ADDENDUM NO. 5

TO: PLANS AND SPECIFICATIONS FOR STATE OF MISSOURI

Renovate Mechanical / Electrical / Life-Safety / State Office Building
Jefferson State Office Building
205 Jefferson Street
Jefferson City, MO 65101
PROJECT NO. O1911-01

SHEET NUMBER:
M3.12
107 OF 244 SHEETS

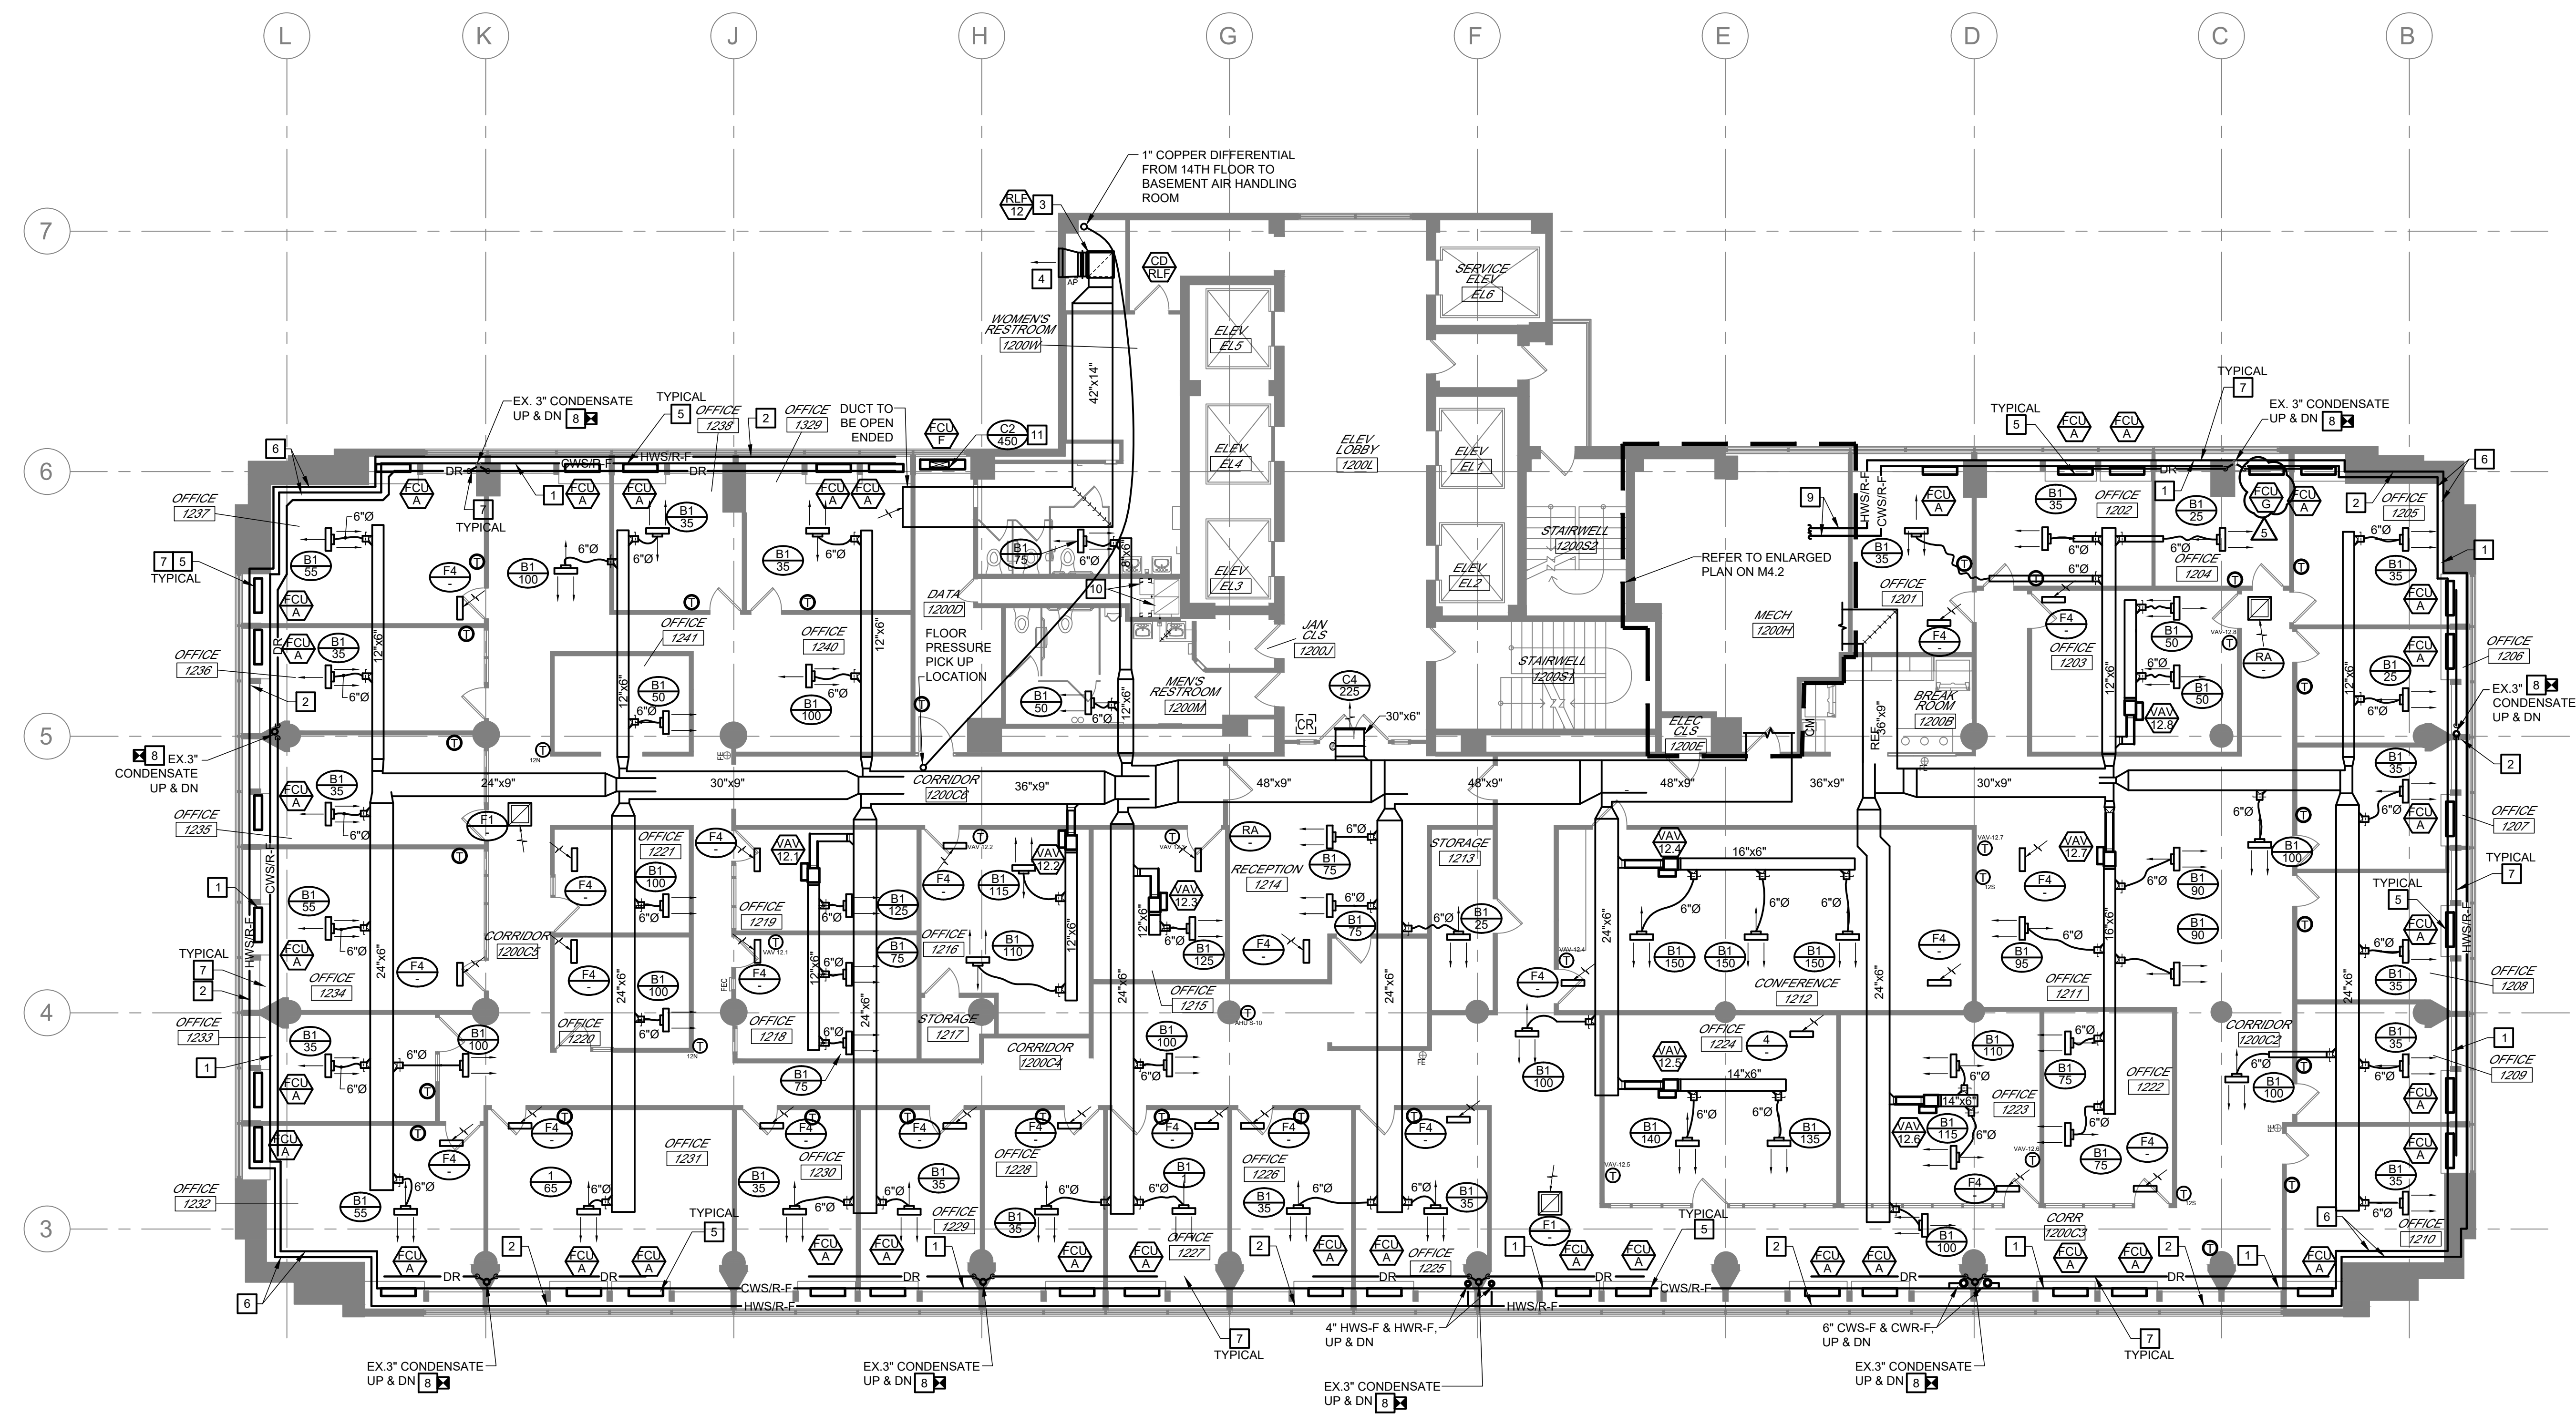
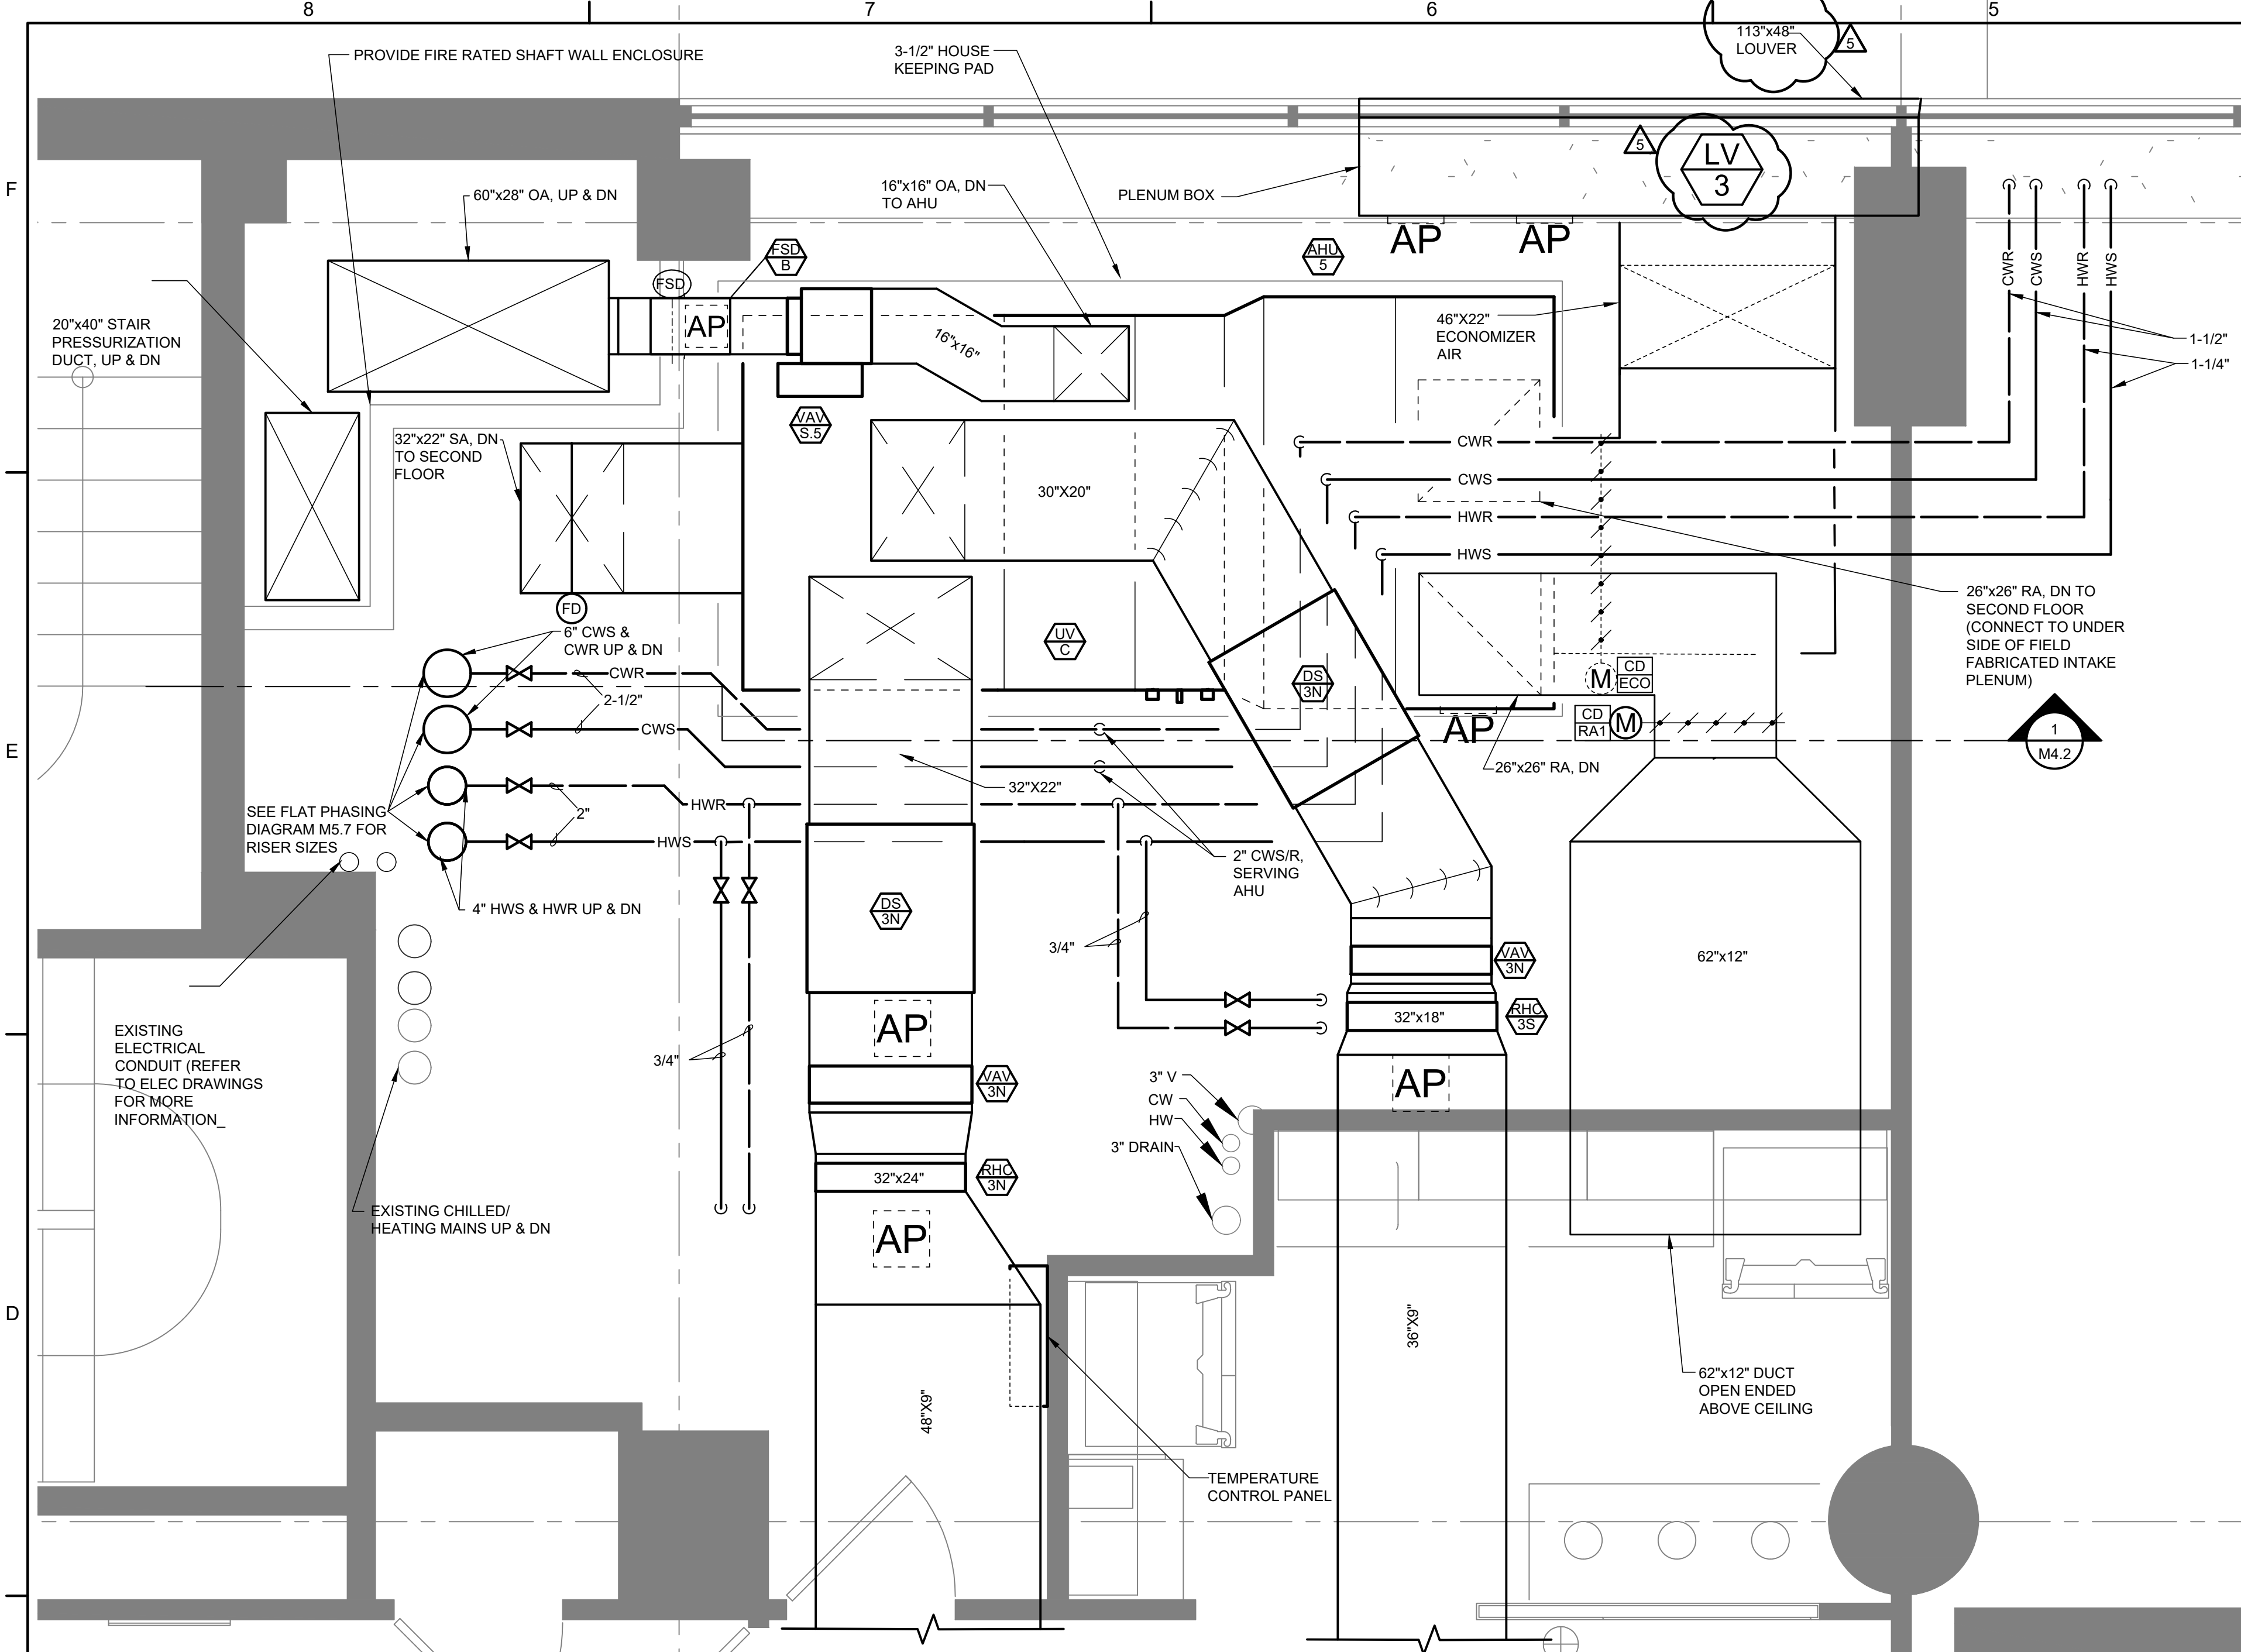
12. Drawing M3.1
- a. ADD - Condensate Piping.
13. Drawing M3.2
- a. ADD - FCU Section.
 - b. Adjust Piping.
14. Drawing M3.3
- a. ADD - FCU Section.
15. Drawing M3.12

- a. Add FCU-G in RM 1204.
16. Drawing M4.2
- a. Lower Designation added.
17. Drawing M5.0
- a. Added general note regarding valves at taps from the risers.

SHEET NUMBER:
M5.1
115 OF 244 SHEETS

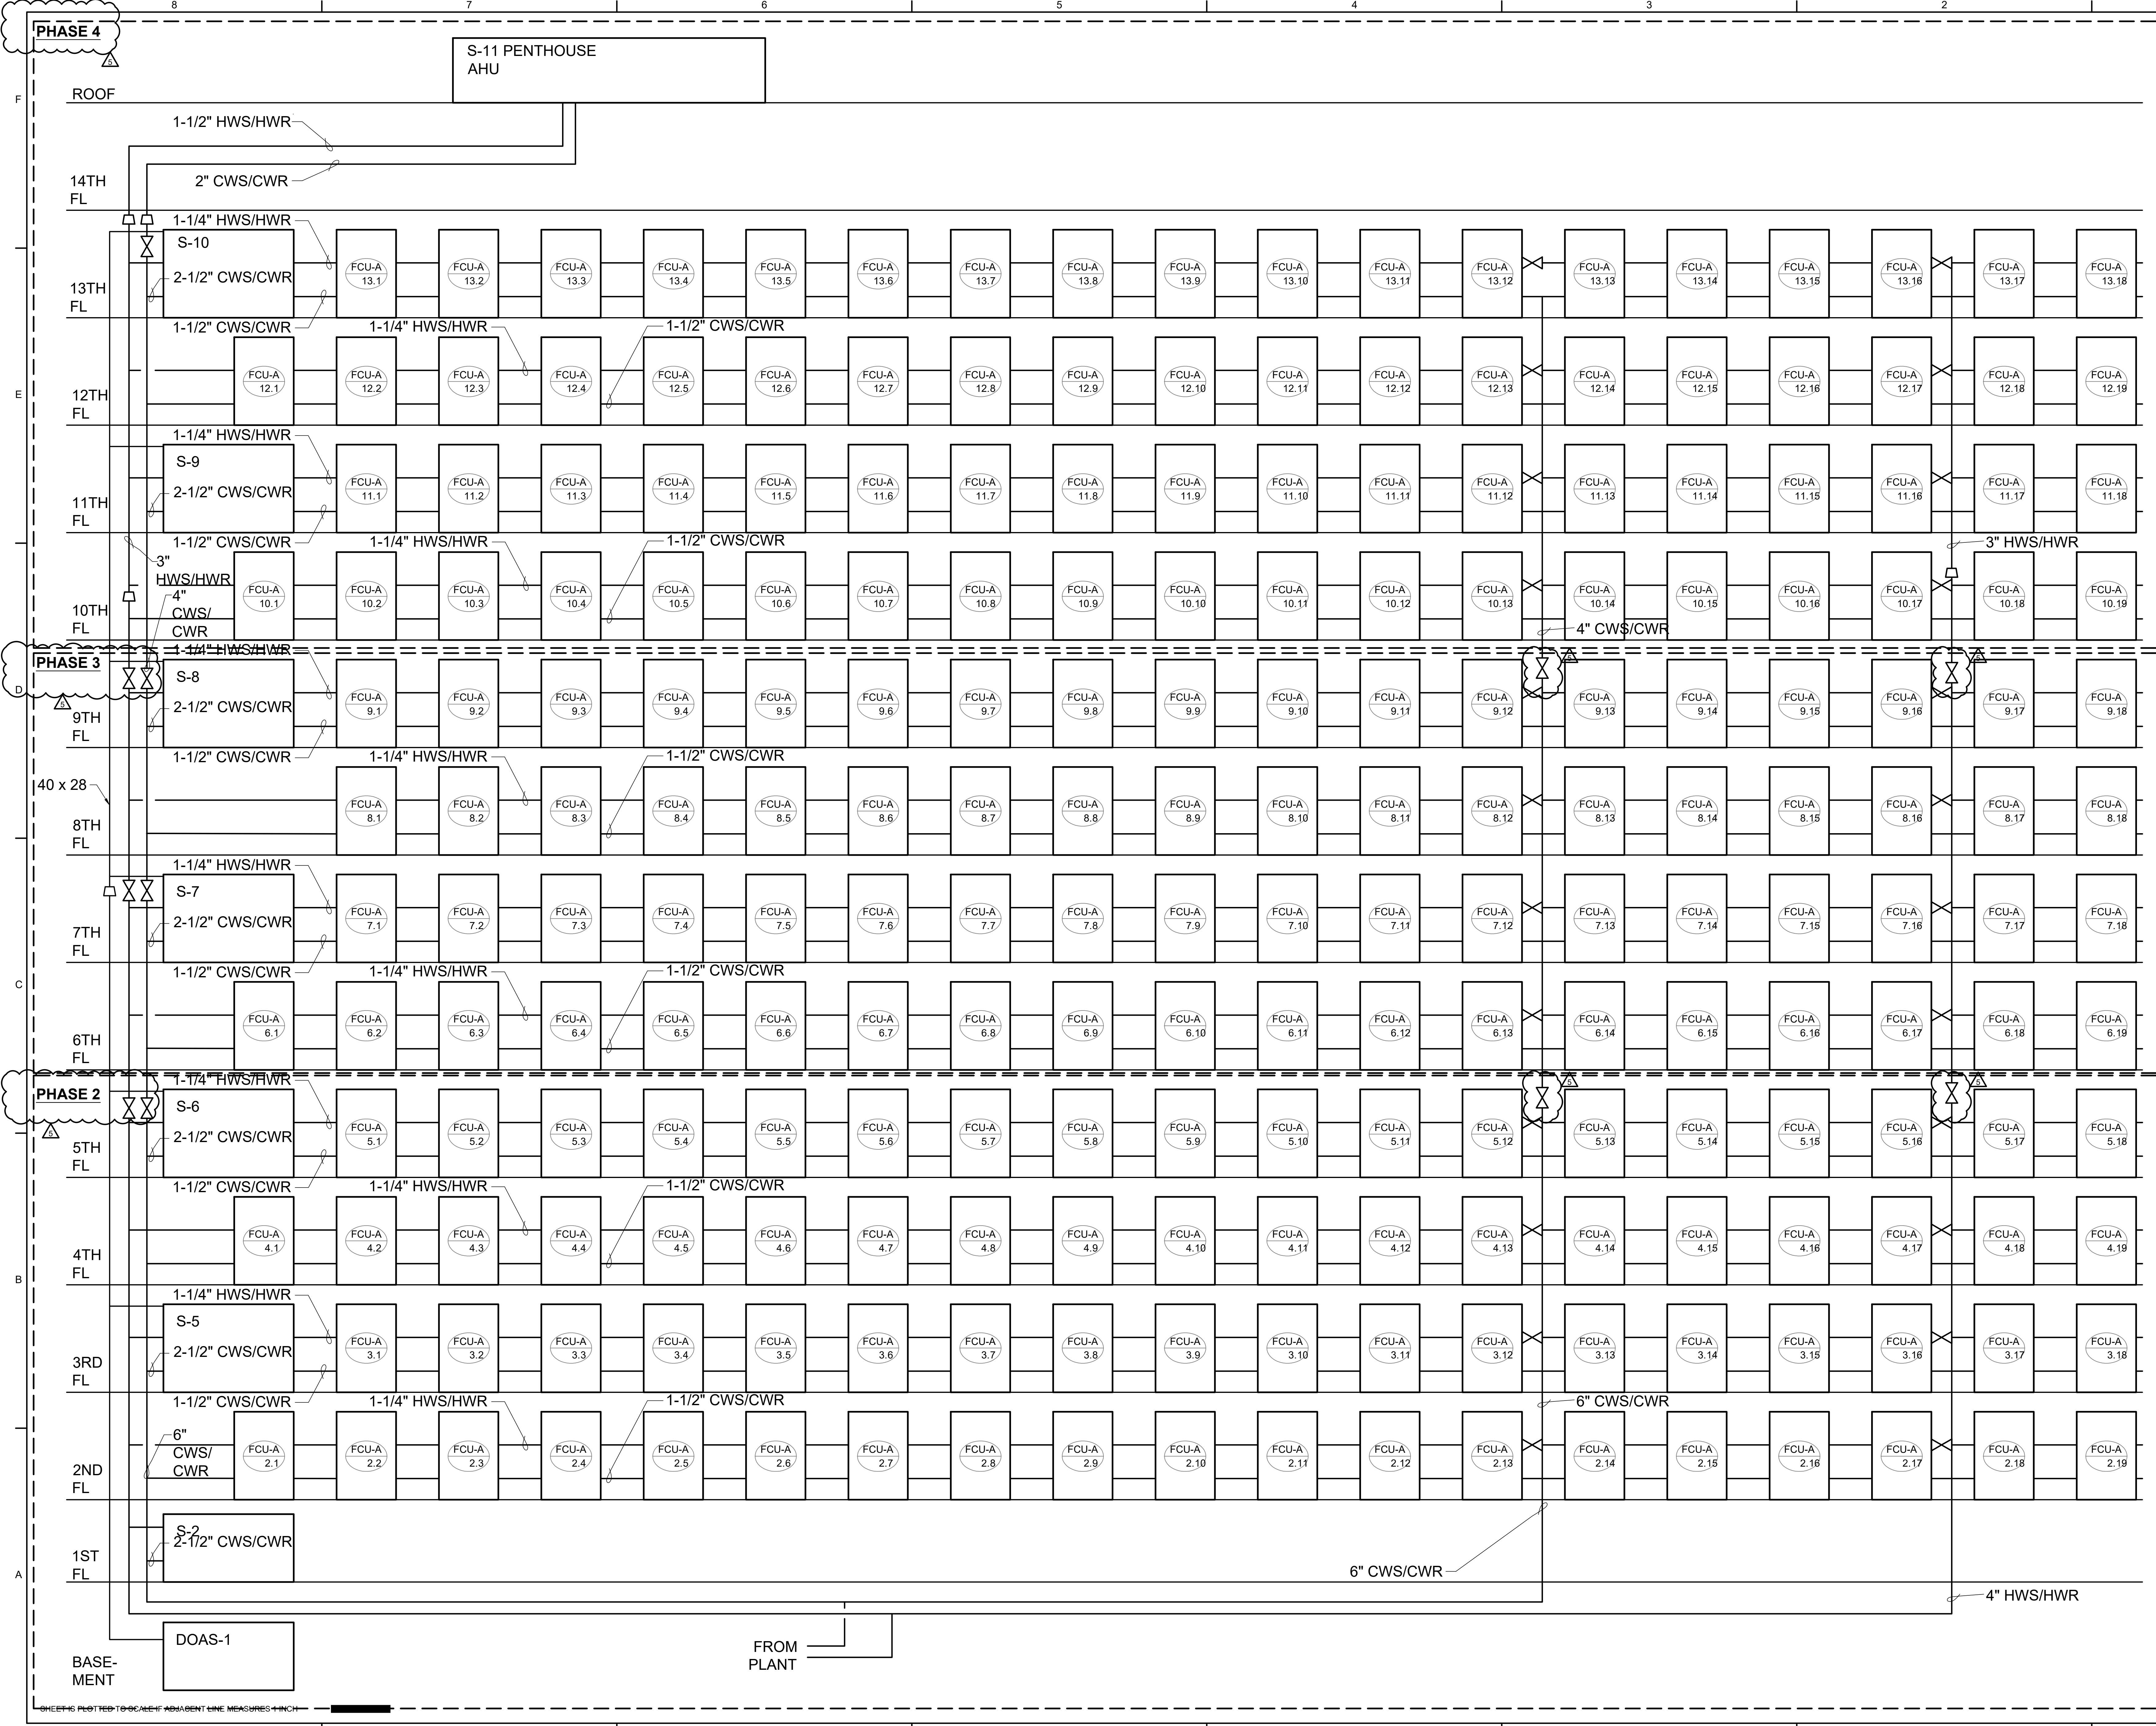
18. Drawing M5.1
- a. Added general note regarding valves at taps from the risers.
19. Drawing M5.6
- a. Phasing diagram adjusted.
